SPEED  UTV

Design Presentation: 13

FOR PUBLIC RELEASE: 06/17/2020

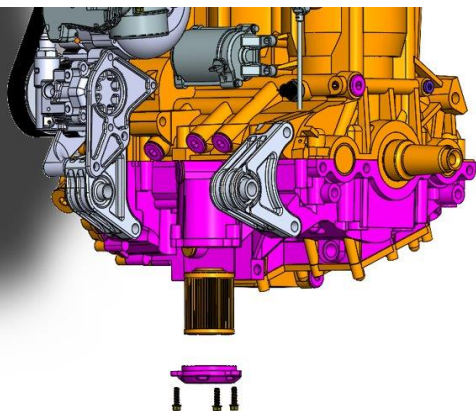
In regards to the oil filter cover plate. Please consider adding a drain plug in the middle of the plate. This way when servicing and changing the oil & filter you can drain the 1/4 to 1/2 quart of oil in that chamber before removing the 3 bolts to drop the plate and pull the oil filter.

If you have ever done a VW bug engine you would understand the mess you make when you start to unbolt the cover as oil starts to seep out around the plate. You end up with oil draining everywhere. On your tools, hands, just running down everywhere. This is why they later came out with a drain plug in the middle of the plate.

We had a boat with an external filter just like this. It too was a disaster to pull the filter cover as oil ended up all in the hull. I ended up drilling a hole in the plate, welding a small nut to the backside of the plate and making my own drain plug. It was still a little messy as the nut step up did not allow it to drain completely. But it was a huge improvement over the quart that drained before.

We have implemented your suggestions and added a drain hole on the oil filter cap in addition to the drain on the pan and dry sump tank.
